MONTGOMERY COUNTY HISTORIC PRESERVATION COMMISSION

Address:	9923 Sutherland Rd., Silver Spring	Meeting Date:	11/17/2021
Resource:	Contributing Resource Polychrome Historic District	Report Date:	11/10/2021
Applicant:	Alicia Gilbert	Public Notice:	11/3/2021
Review:	HAWP	Tax Credit:	n/a
Case No.:	967878	Staff:	Dan Bruechert
Proposal:	Front Door Replacement

Figure 2: Front door of the subject property.

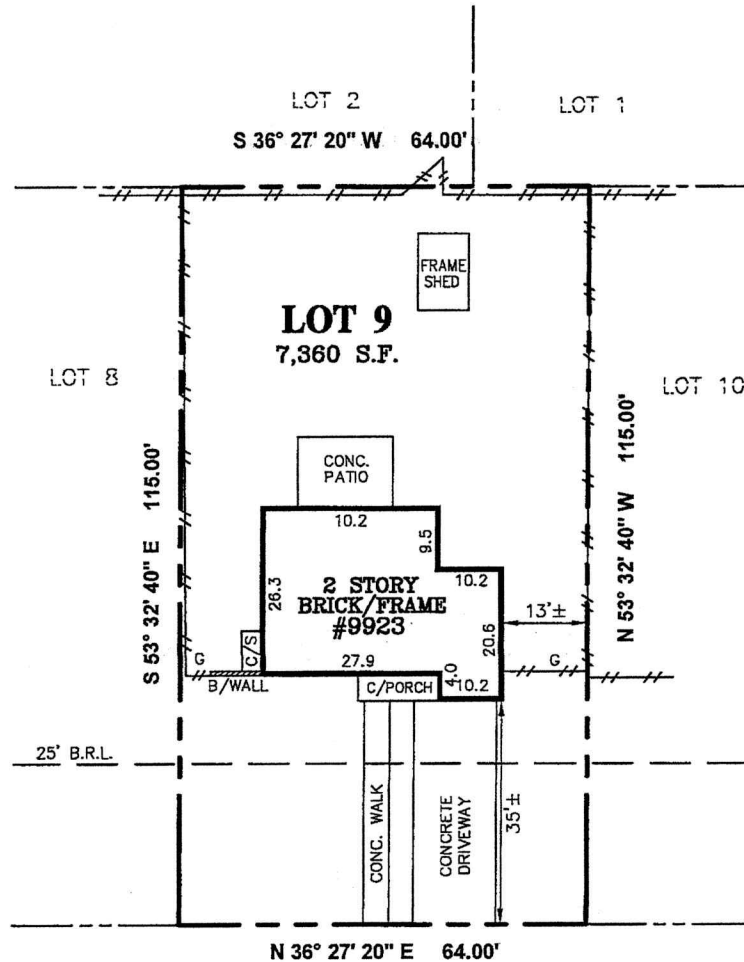
The existing front door is a wood, flat panel door, with a small single square window (see below), installed in a niche in the front wall.

The front door appears to be original based on Staff's review of HP photos, site visits, and the condition of the other Polychrome houses. The simple design would have been selected so that it does not detract from the house's decorative concrete walls. Unlike the windows, which were selected to align with decorative features on the walls, it appears the door was selected to visually recede and not distract from the house's highly decorative elements.

The door and jamb have degraded over the years and there are gaps between the door and the jamb to the point that light is visible in the gaps between (see the application). Staff finds the door has degraded beyond repair and that a replacement door is appropriate.

Typically, fiberglass doors are not considered appropriate for historic buildings. The profiles are generally not compatible with a wood door and the finish is not consistent with a painted door. In this instance, the profile of the existing door is flat, so Staff does not have concerns about the replacement door's profiles. Additionally, the front door will be painted to match other features on the house.

Staff finds changing the door configuration from a one-lite to a three-lite door will not alter the character of the front of the house to a degree that the new door will detract from the house or the surrounding district and recommends the HPC approve the HAWP.
